**STAFF REPORT**  
**COMMUNITY DEVELOPMENT DEPARTMENT**

HEARING DATE: 10/21/2021  
 TO: Planning & Zoning Commission  
 FROM: Alan Tiefenbach, Associate Planner  
 208-884-5533  
 Bruce Freckleton, Development Services Manager  
 208-887-2211  
 SUBJECT: H-2021-0062  
 Meridian South Fire Station & Police Substation Conditional Use Permit  
 LOCATION: 2385 E. Lake Hazel Rd  
 South side of E. Lake Hazel Rd, between S. Locust Grove Rd. and S. Eagle Rd.

Conditional Use Permit to develop a 11,637 sq. ft. fire station and 11,560 sq. ft. police substation building (public or quasi-public use) on approximately 4 acres of land in the R-8 zoning district.

**A. Site Plan (date: 8/26/2021)**

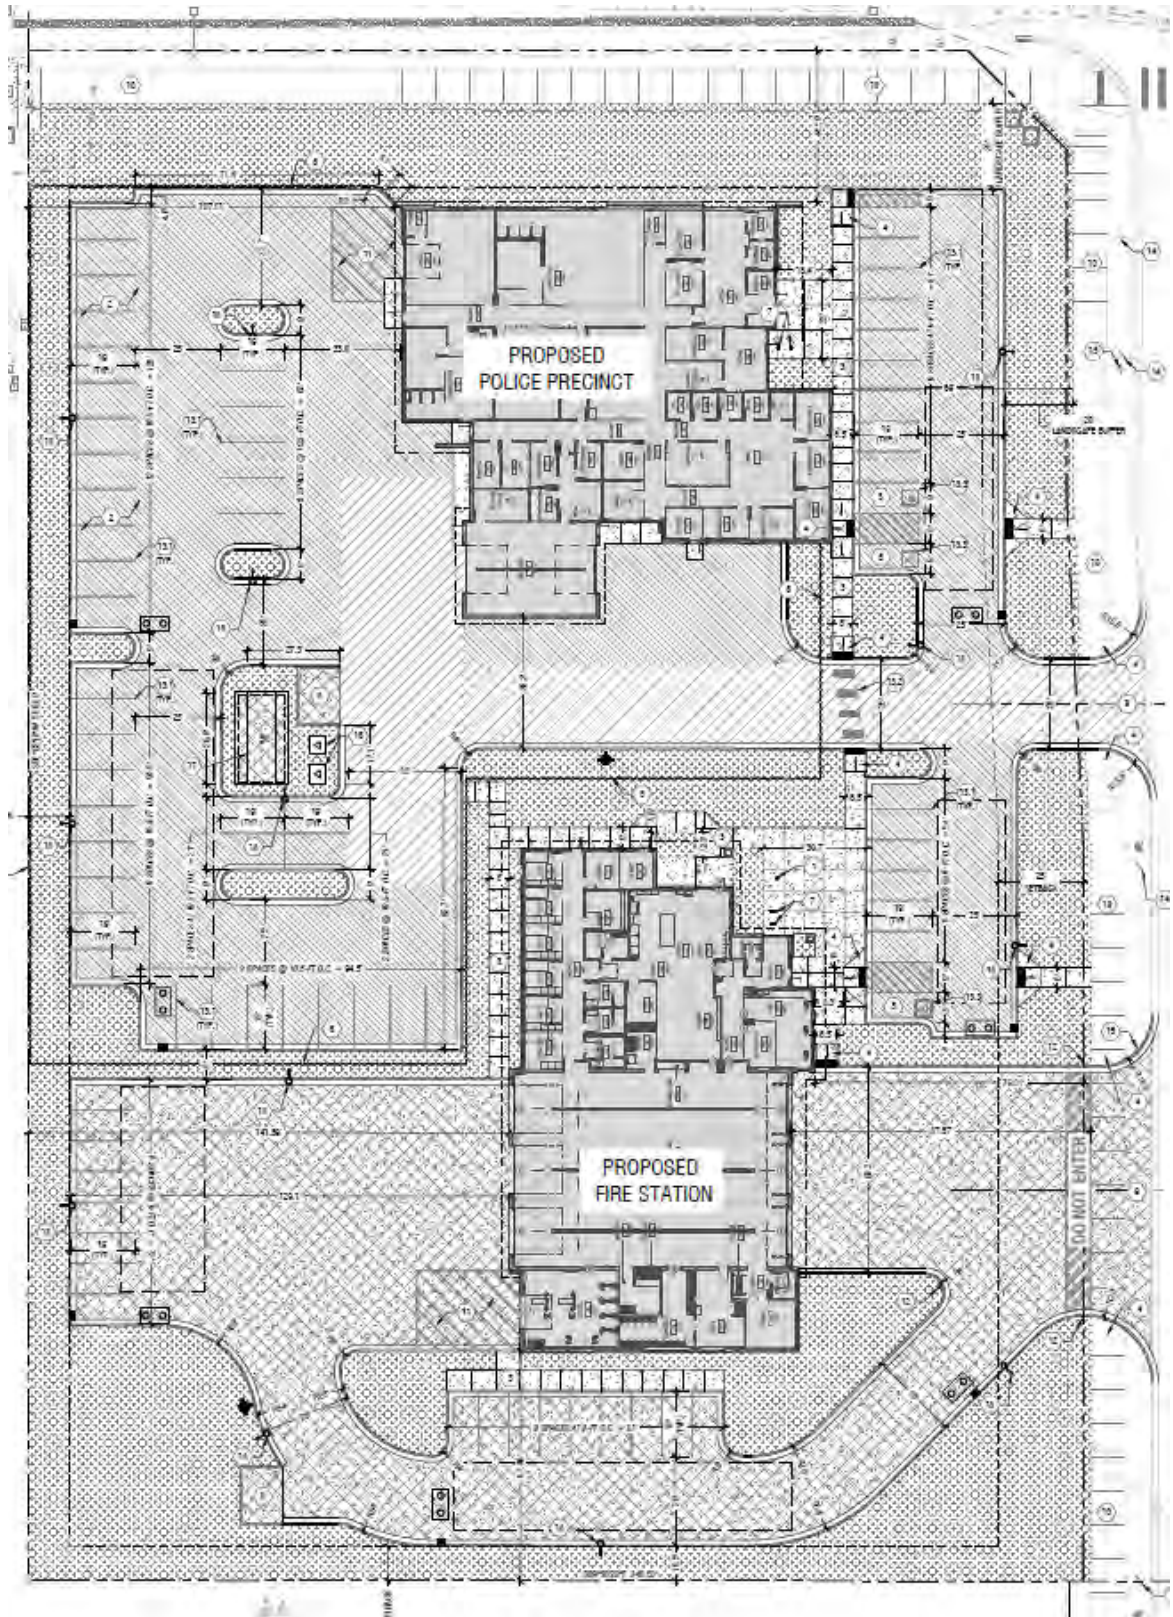
The City has proposed to construct 2 driveways from the site to the new collector roadway; one for the police station and a wider driveway for the fire station. The 2 existing driveways from the site onto Lake Hazel Road will be closed. Direct access is prohibited to Lake Hazel Road in accord with UDC 11-3A-3.

Wrought-iron security fencing of up to 8' in height is shown on the site plan. Staff notes fencing height is limited to 6' in height in the R-8 zone district. The City should apply for alternative compliance concurrently with the CZC.

9. Direct access to E. Lake Hazel Rd is prohibited in accord with UDC 11-3A-3.
10. The required landscape buffers along streets shall be constructed consistent with the standards as set forth in UDC 11-3B-7C in accord with the installation schedule in UDC 11-3B-14.

11. All ACHD conditions of approval shall be complied with.
12. All parking lots shall meet the standards as required per UDC 11-3B-8C.
13. All proposed fencing and/or any fencing shall be constructed as required by the UDC, consistent with the standards as set forth in UDC 11-3A-7 and 11-3A-6B, as applicable, or developer shall submit a concurrent alternative compliance to increase the fence height.

B. Landscape Plan (date: 8/26/2021)

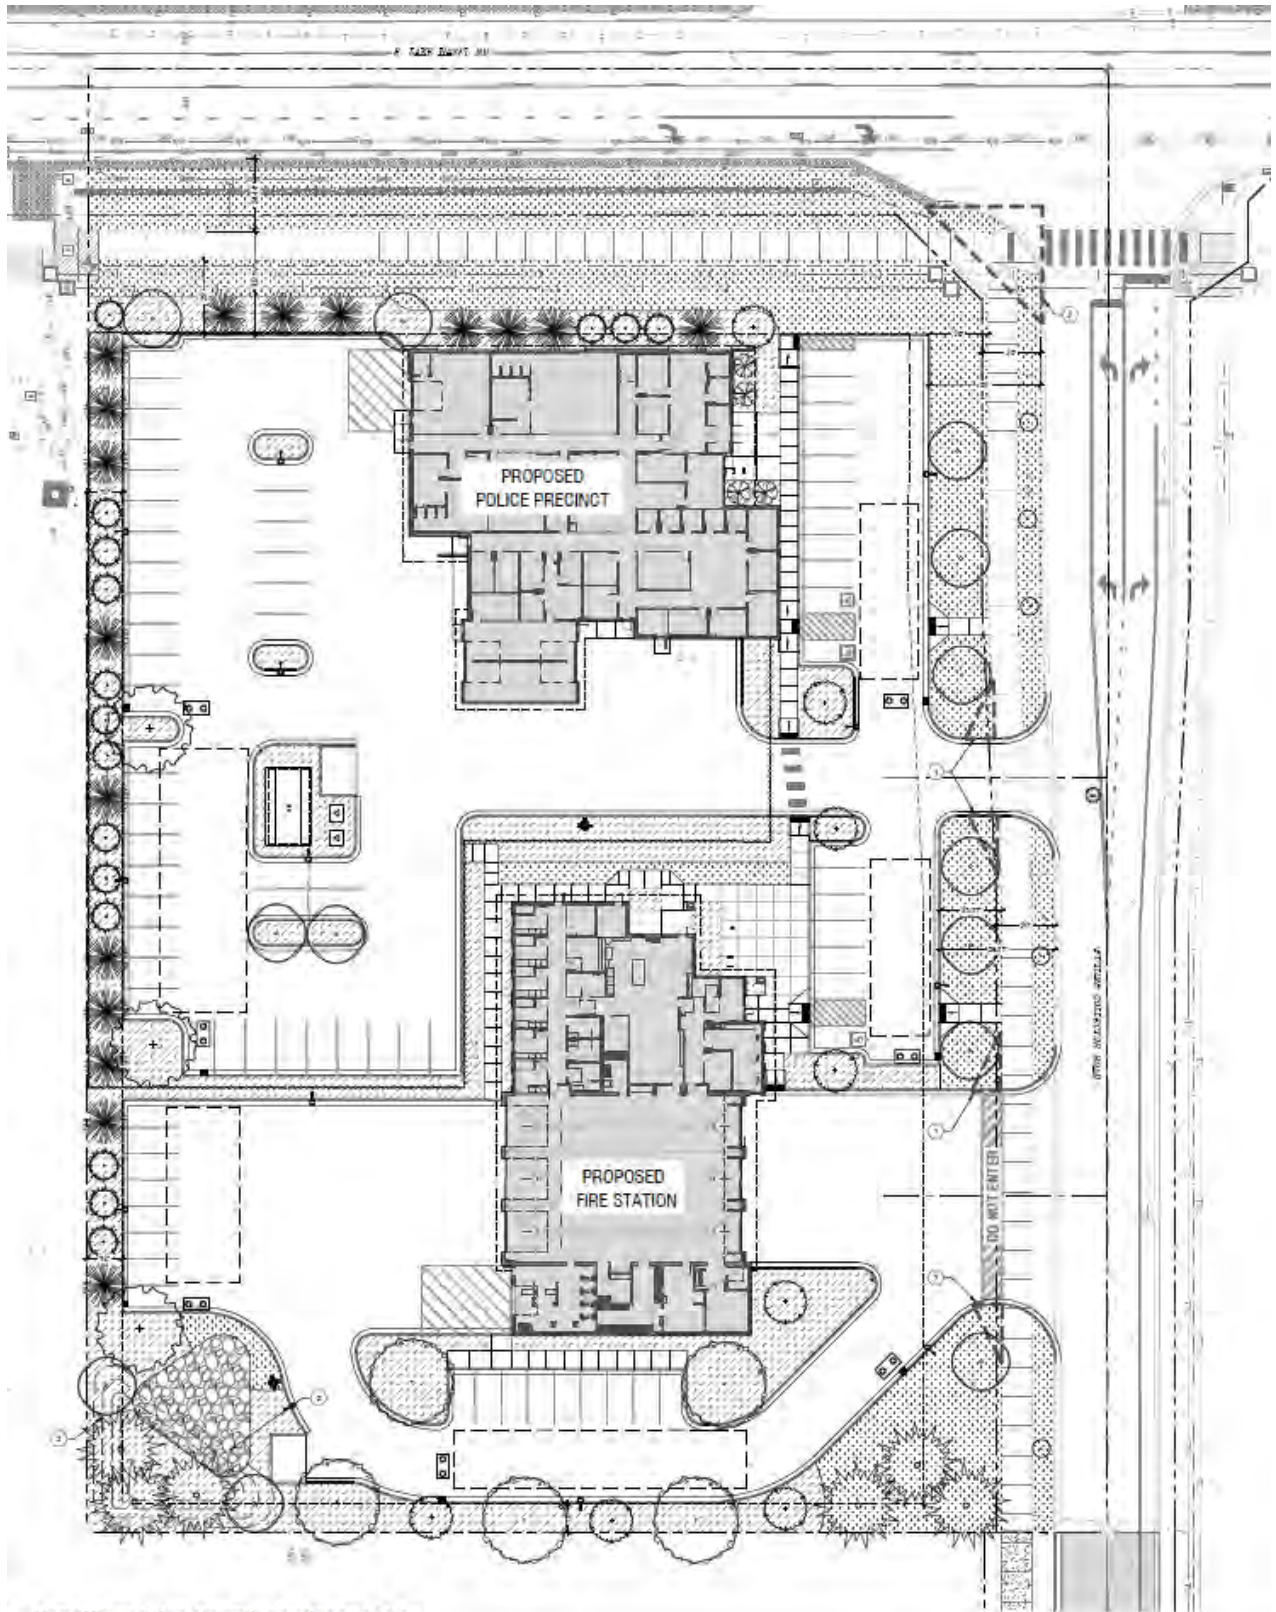
The parking plan appear to meet most of the landscaping requirements of UDC 11-3B-8 except there are several landscape islands which do not reflect trees as required by UDC 11-3B-8. Also, pedestrian crossings across the drive aisles are striped whereas UDC 11-3A-19 requires the internal pedestrian walkway to be distinguished from the vehicular driving surfaces through the use of pavers, colored or scored concrete, or bricks. This should be addressed at the time of CZC submittal.

The landscape plan indicates a buffer of at least 40 ft. in width from the property line along W. Lake Hazel Rd. (the pathway is included in this buffer) and 20 ft. wide from the property line along the collector to the east (although the 10 ft. wide pathway is outside of the property line. As mentioned above in the parking analysis, there are several internal landscape islands without trees which must be landscaped in accord with UDC standards set forth in UDC 11-3B-8C.

C. Fire Station Elevations (date: 8/27/2021)

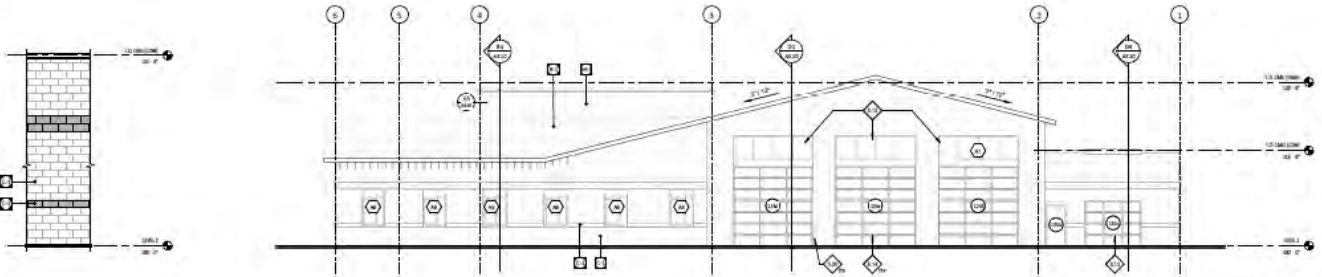
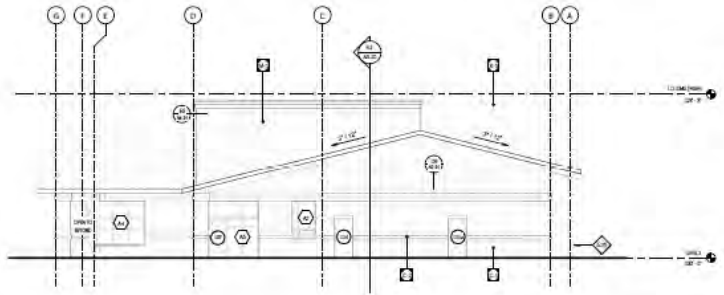
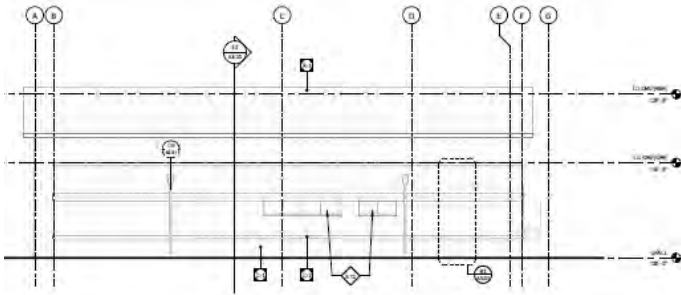
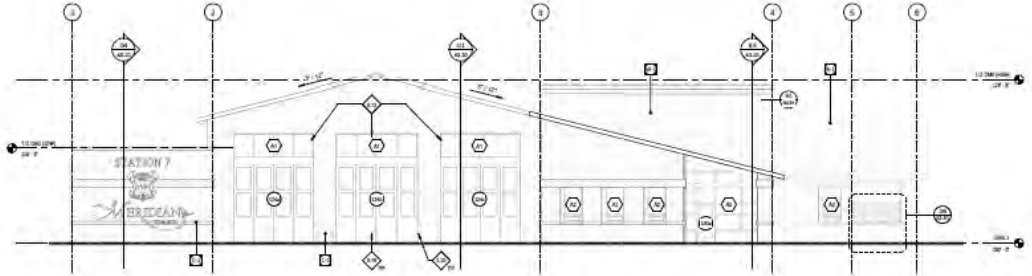
Staff is not certain the building elevations as submitted meet the minimum requirements of the ASM for commercial buildings. The only field materials indicated on the elevations are smooth face CMU and horizontal metal panel whereas 5.1B requires at least two distinct field materials (material of more than 20% of the façade) and only allows metal panel and untextured concrete as a field material if there are at least two other qualifying field materials. At least 30% of the façade must use a combination of concrete, masonry, stone or unique variation in color around the base of the building, whereas it does not appear there are any distinct materials along the base. It does not appear there is at least 30% fenestration or a fenestration alternative as required per ASM 3.3E on the facades of the buildings. Finally, the elevations that were approved as part of the annexation indicated timber frame accents and overhangs over entrances, whereas it appears these elements have been removed from the updated drawings. At the time of Certificate of Zoning Compliance (CZC) and Design Review (DE) the standards of the ASM must be met, or design exceptions may be granted.

1. A Certificate of Zoning Compliance and administrative design review application is required to be submitted to the Planning Division and approved prior to submittal of building permit applications. The buildings shall either meet all architectural requirements of the Architectural Standards Manual (ASM) or there should be a request for a design exception as part of the CZC submittal.

5. All structures shall comply with the design standards listed in the Architectural Standards Manual and the design standards listed in UDC 11-3A-19. An application for Design Review shall be submitted concurrently with the Certificate of Zoning Compliance application and approved prior to submittal of building permit applications.
